HISTORIC AND DESIGN REVIEW COMMISSION

August 07, 2024

HDRC CASE NO: 2024-260
ADDRESS: 123 ALAMO PLAZA
LEGAL DESCRIPTION: NCB 145 BLK LOT 8 & N E 6 FT X 78 FT OF 9
ZONING: D, H, RIO-3
CITY COUNCIL DIST.: 1
DISTRICT: Alamo Plaza Historic District
APPLICANT: Norman Barrera/Garza Bomberger & Associates
OWNER: Andrew Hull/KIRKPATRICK VENTURES LLC
TYPE OF WORK: Storefront replacement, door installation
APPLICATION RECEIVED: July 19, 2024
60-DAY REVIEW: September 17, 2024
CASE MANAGER: Edward Hall

SHEET TITLE:
EXTERIOR ELEVATIONS -
LOSOYA

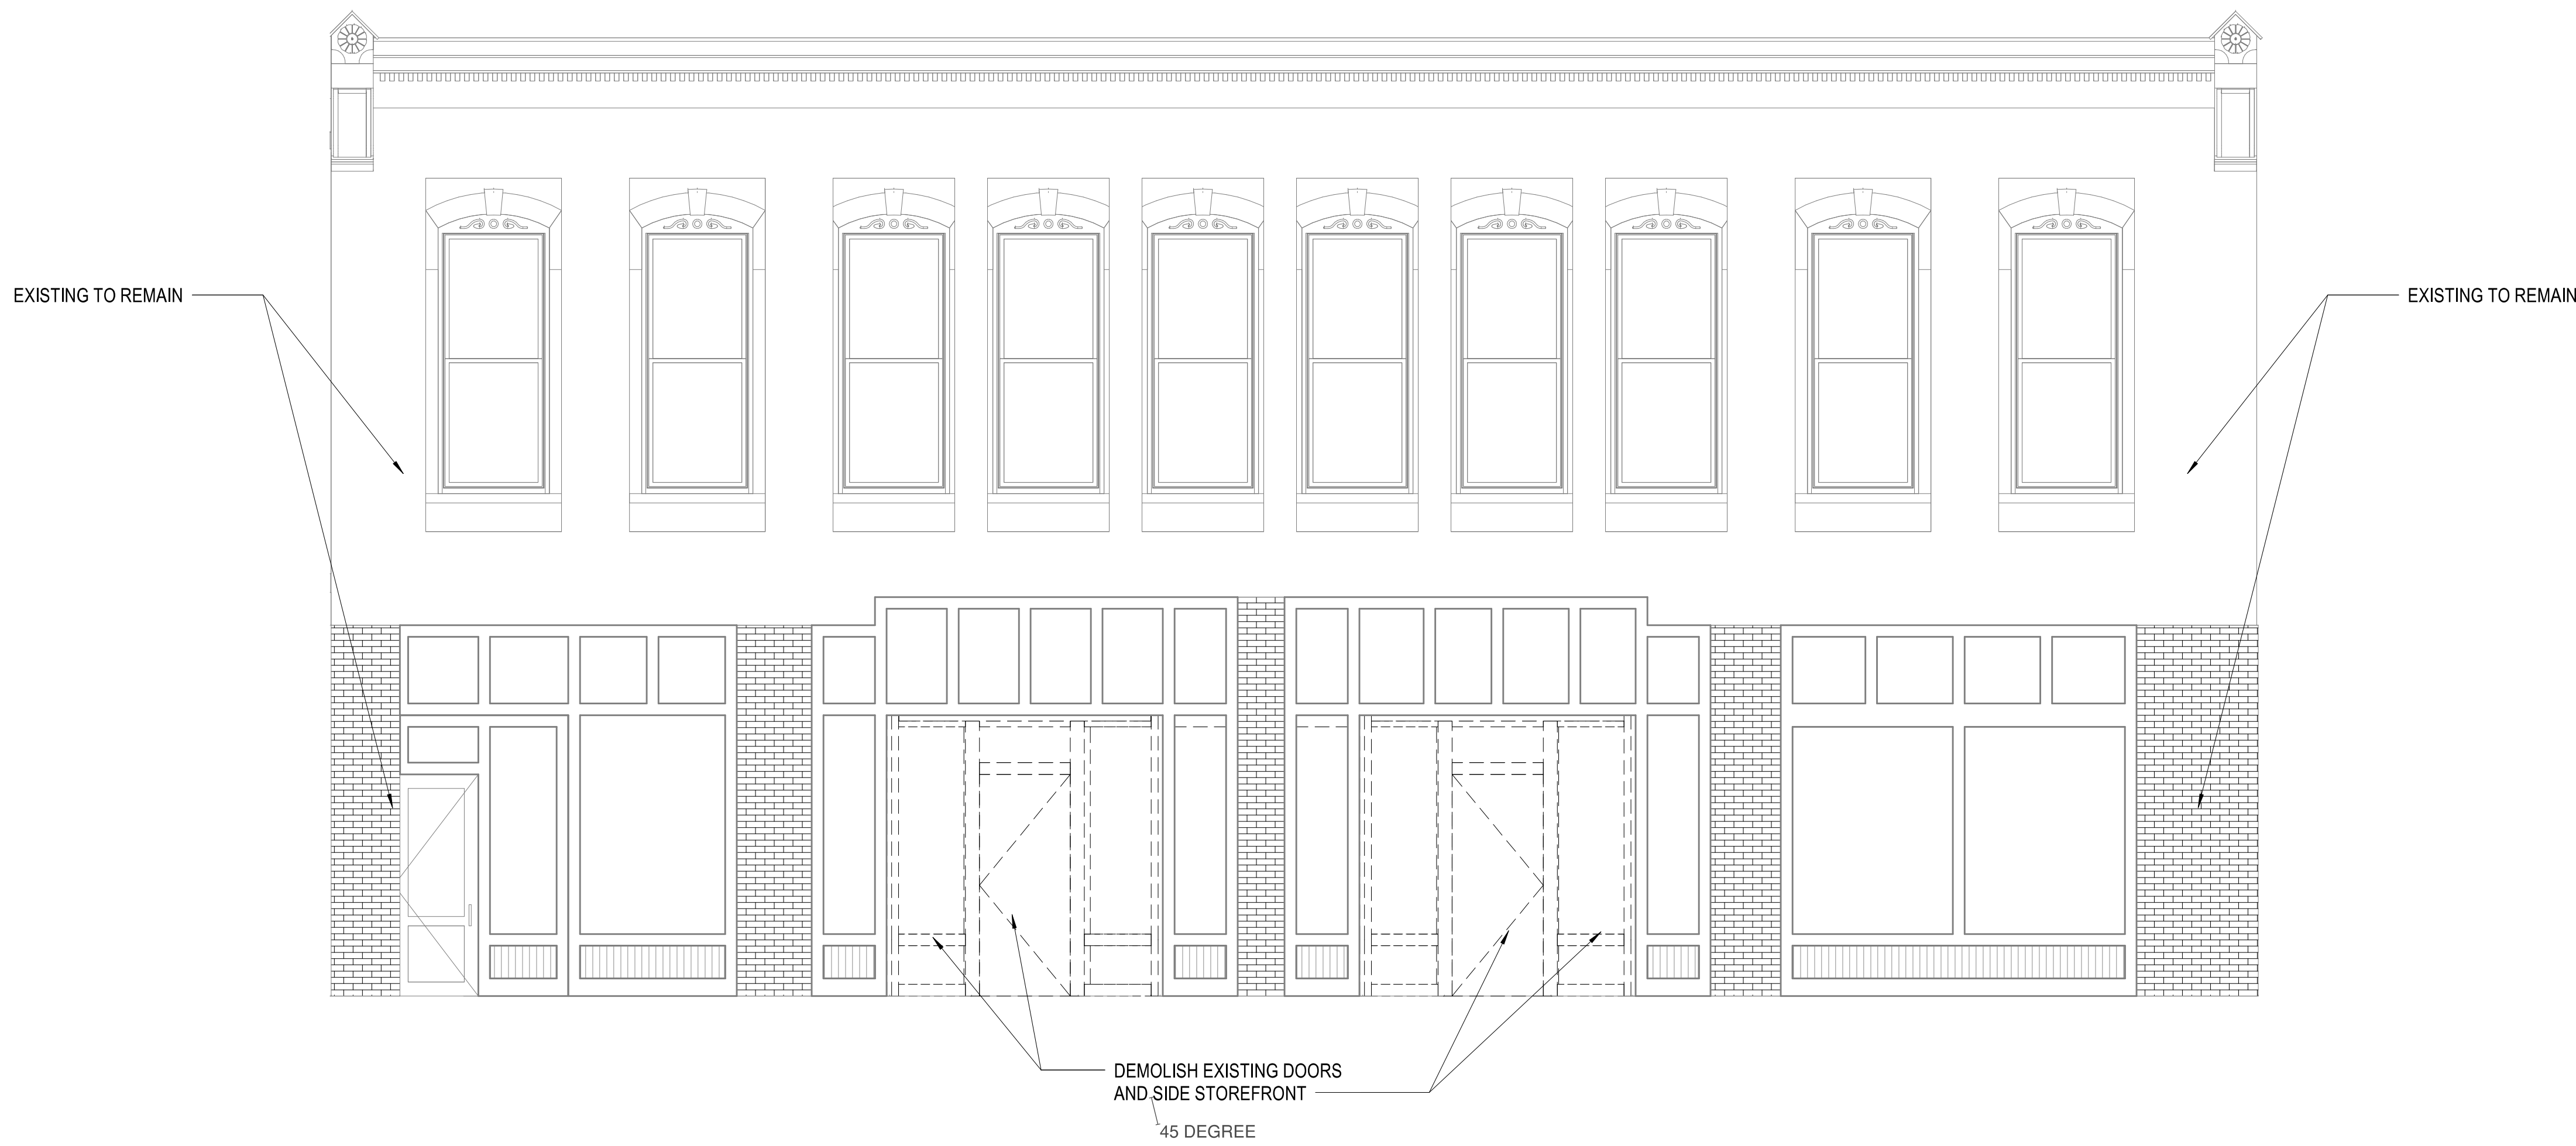
- c. DOOR INSTALLATION (Lasoya Façade) – The applicant has proposed to install a set of doors to serve as dumpster gates on the west (Losoya) façade to match the existing, adjacent doors. The proposed doors will enclose a non-original recessed entrance where dumpsters and trash bins are currently being stored. Staff finds this to be appropriate. Final door specifications are to be submitted to OHP staff for review and approval.

- i. That the applicant submits final construction document to OHP staff for review and approval. Construction documents should include specifications and details as well as measurements.
- ii. That final door specifications are submitted to OHP staff for review and approval.
- iii. ARCHAEOLOGY – The project shall comply with all federal, state, and local laws, rules, and regulations regarding archaeology, as applicable.

SHEET TITLE:
EXTERIOR ELEVATIONS -
ALAMO PLAZA

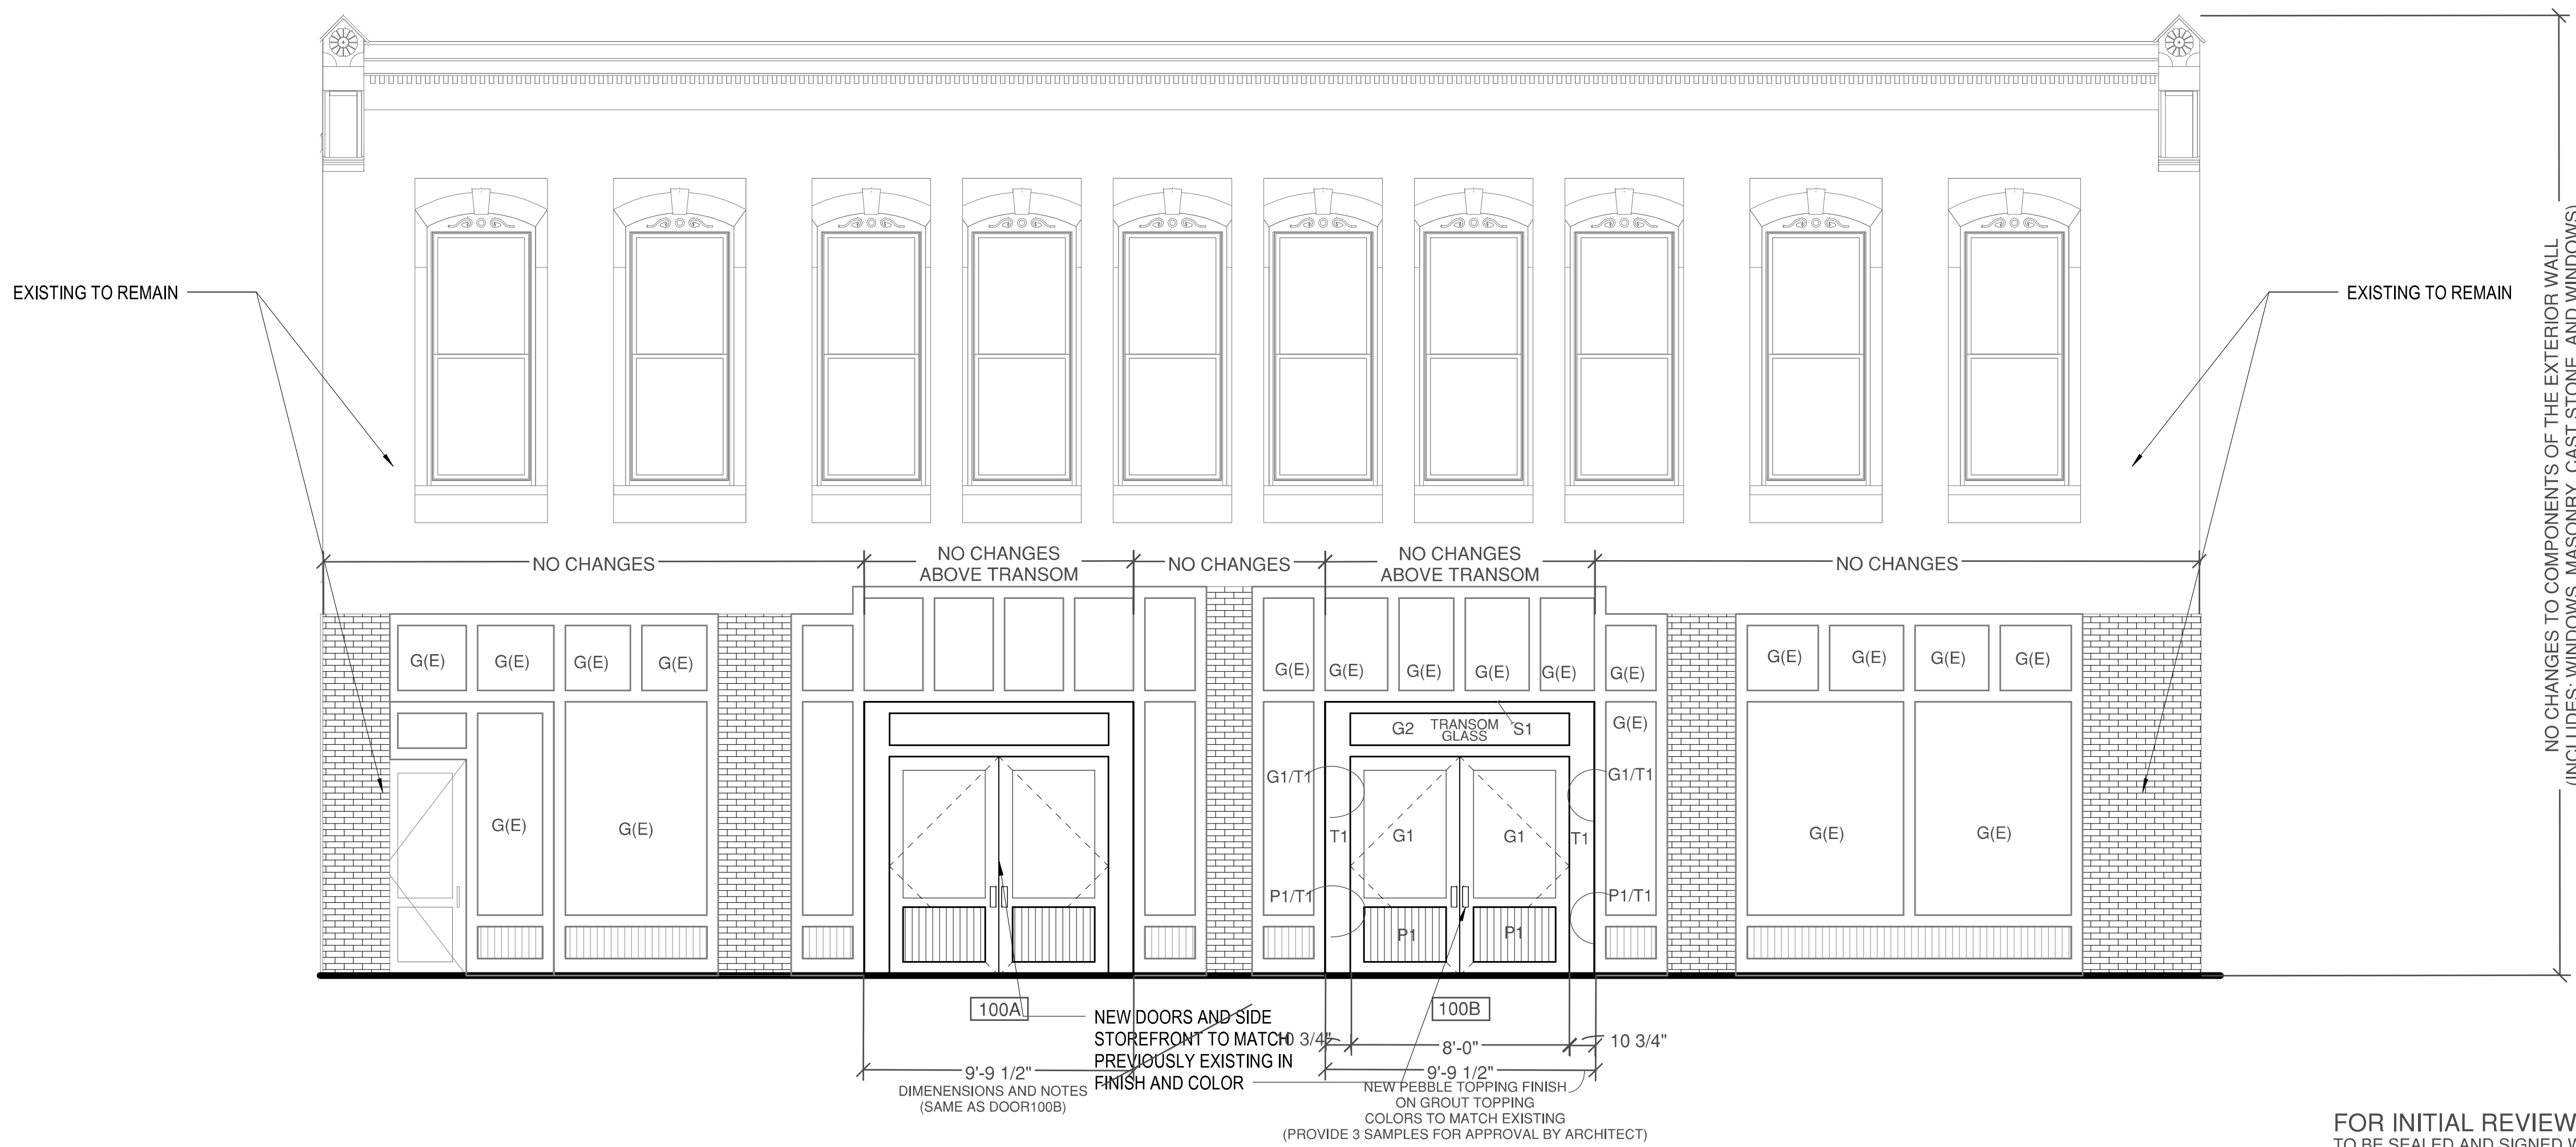
- b. STOREFRONT REPLACEMENT (Alamo Plaza Façade) – The applicant has proposed to replace the existing, non-original storefront within the east (Alamo Plaza) façade with a new, wood storefront system to feature two sets of double doors with square sidelites. The applicant has not proposed to modify the transom windows. Currently, the non-original storefront features single-width doors with sidelites at 45-degree angles. The Guidelines for Exterior Maintenance and Alterations 10.B.ii. notes that non-historic facades should be returned to their original designs based on photographic evidence. If evidence of the original façade is not available, the scale, design, materials, color and texture of the proposed storefront system should be compatible with the historic building. The applicant has provided photographs of the historic structure from the 1970's, noting that the current storefront system is not original. Generally, staff finds the profile of the proposed storefront system to be appropriate. Staff finds that final, detailed construction documents should be submitted to OHP staff for review and approval, to include measurements and detail information.

Staff recommends approval of items #1 and #2 based on findings a through c with the following stipulations:
